# ADDENDUM NO. 3

## PASSENGER BOARDING BRIDGES REPLACEMENT

**GREATER BATON ROUGE AIRPORT DISTRICT  
BATON ROUGE METROPOLITAN AIRPORT  
EAST BATON ROUGE PARISH**

**DATE ISSUED: 14<sup>TH</sup> FEBRUARY, 2023**

C1.2

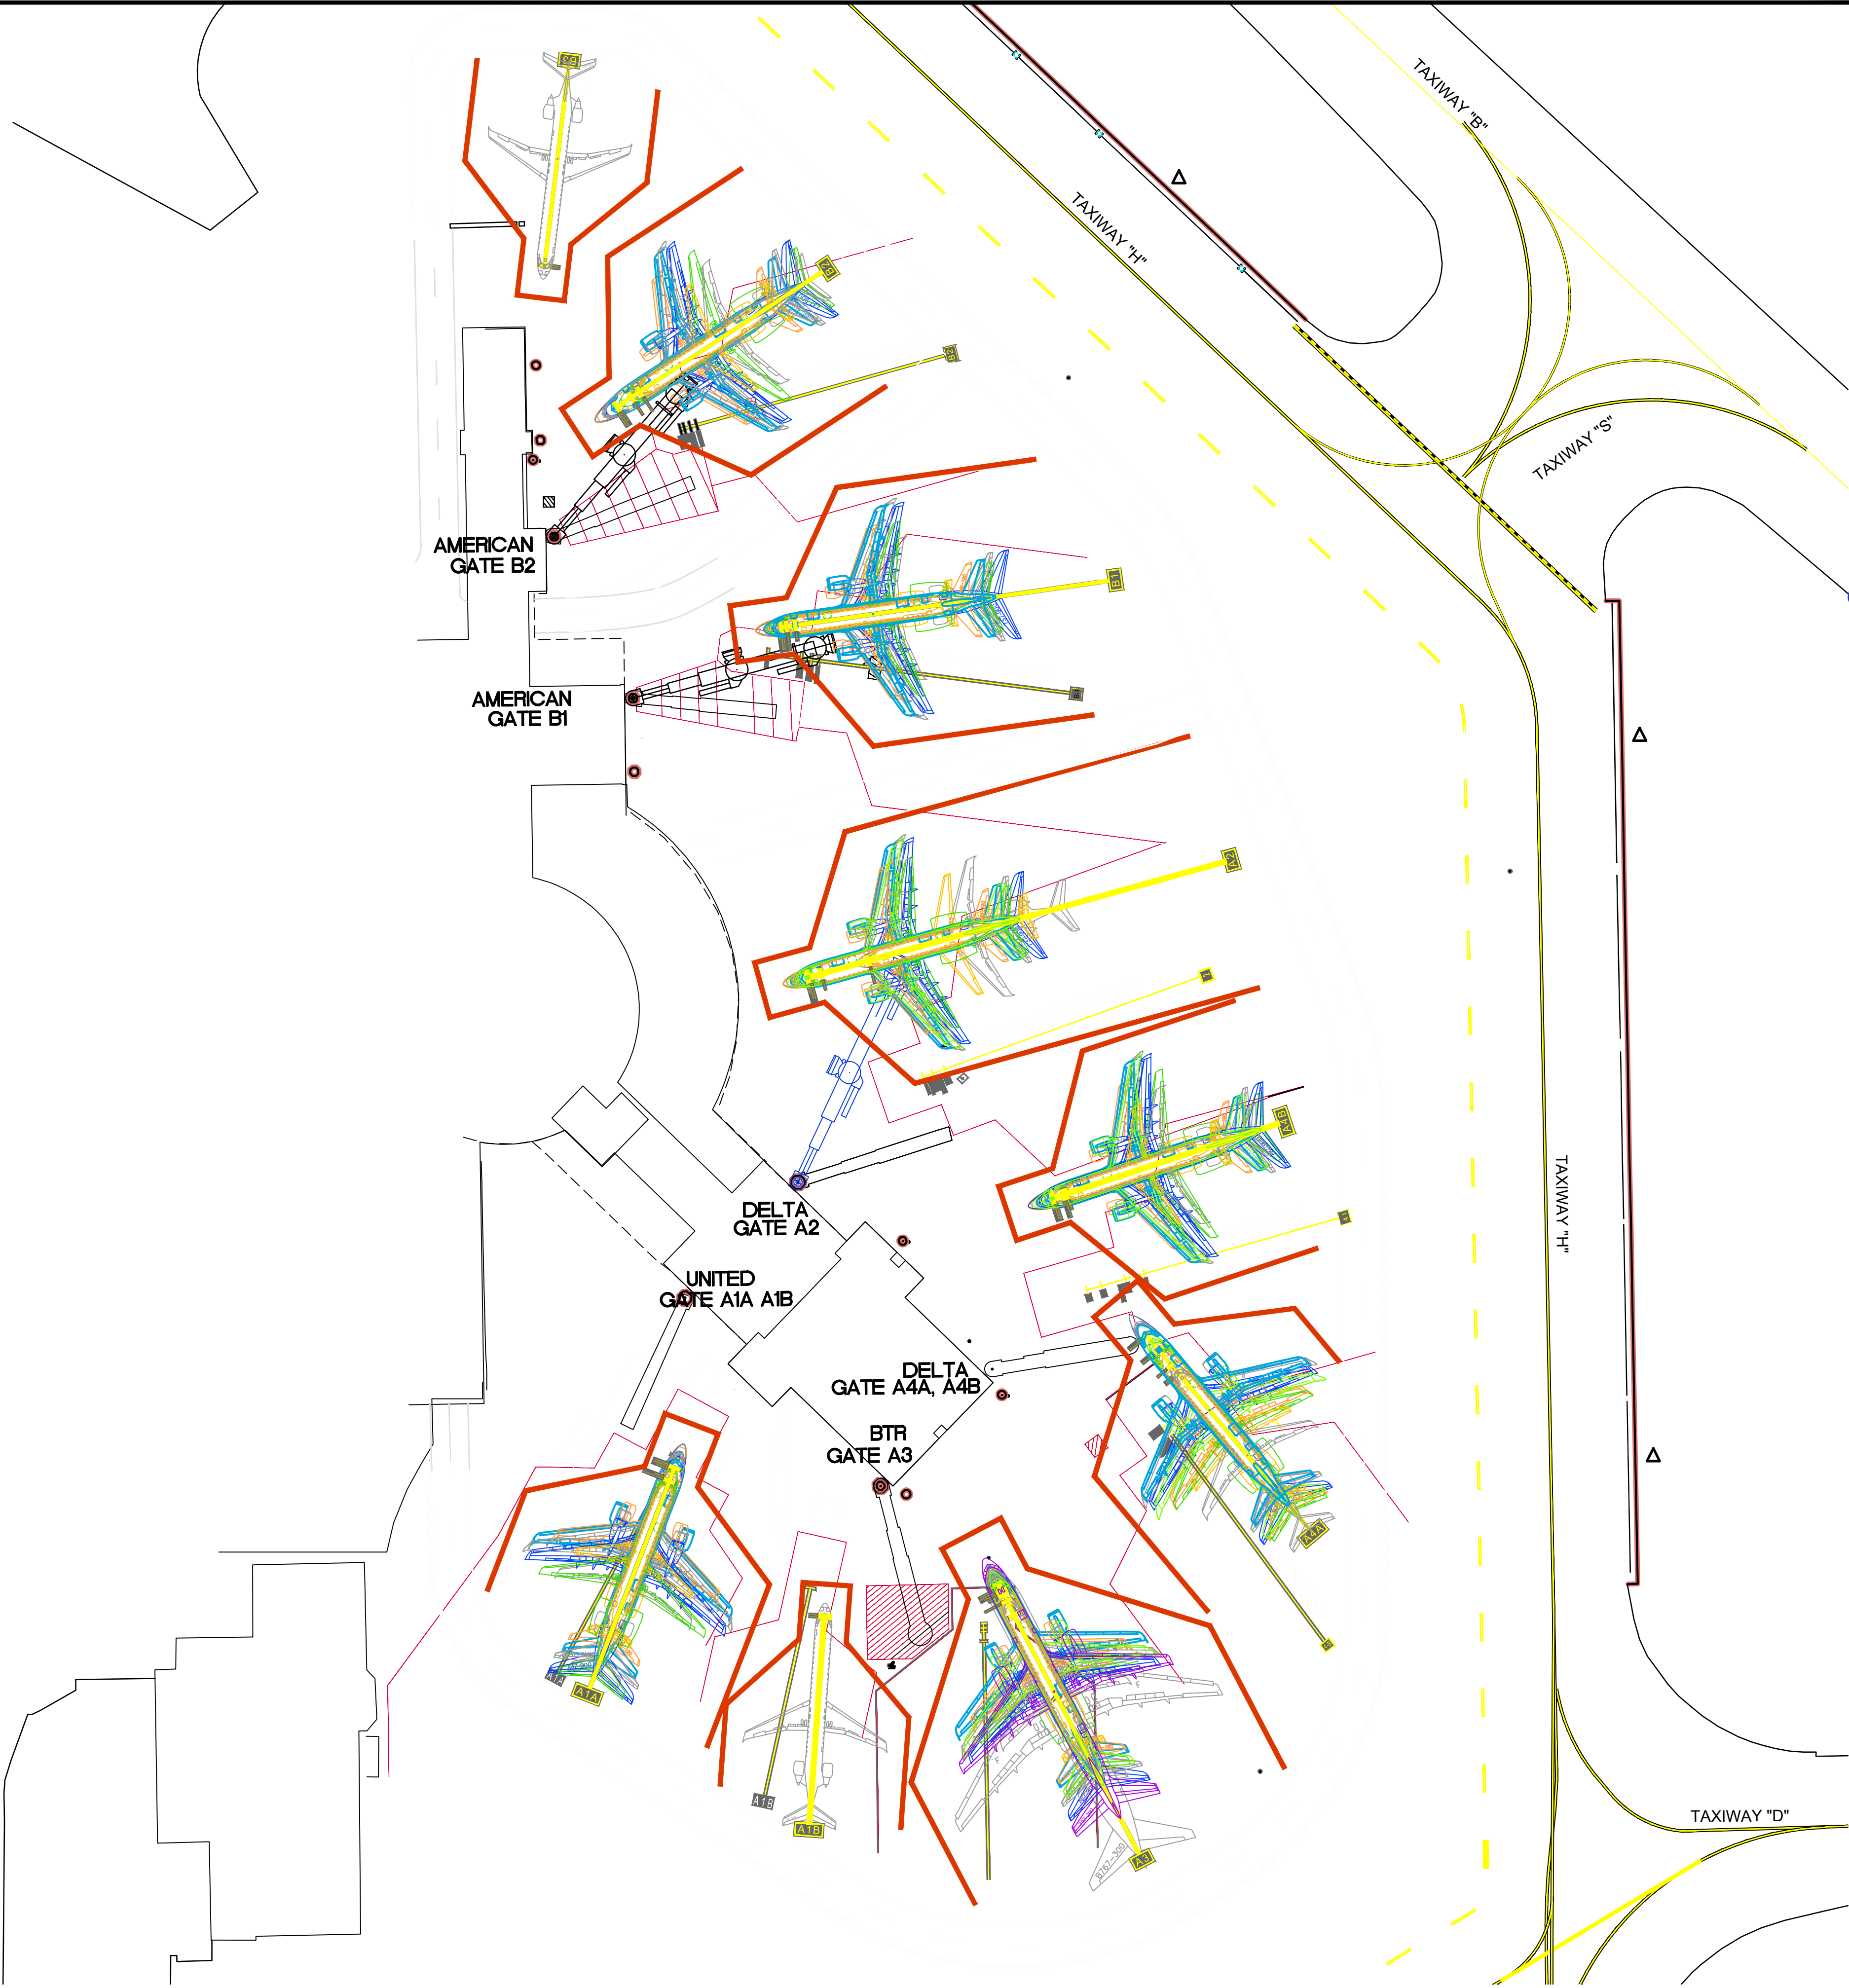
- B. **DELETE SHEET** C1.2 and **REPLACE** with revised sheet C1.2
- *Revised “Sheet C1.2 CONSTRUCTION SAFETY & PHASING PLAN (PROJECT LAYOUT PLAN NO. 2)”*

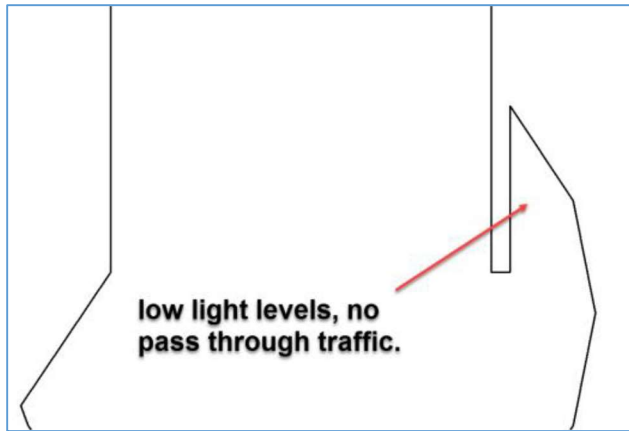
**5. 4.3 Lighting shall be provided along the entire length of the PBB to include the boarding path, landing sill, platform, cab, and operator compartment. Lighting systems shall be designed to provide a 20 foot candles or greater as measured at any point on floor level. JBT lighting can meet an average level of 20 foot candles. Due to tunnel design there are non-traffic area where the levels are below 20 foot candles (left side opposite from the service door, see sketch). Please indicate that the lighting levels are an average level or allow this area to be below stated requirements. Is this acceptable?**

**A: Yes**
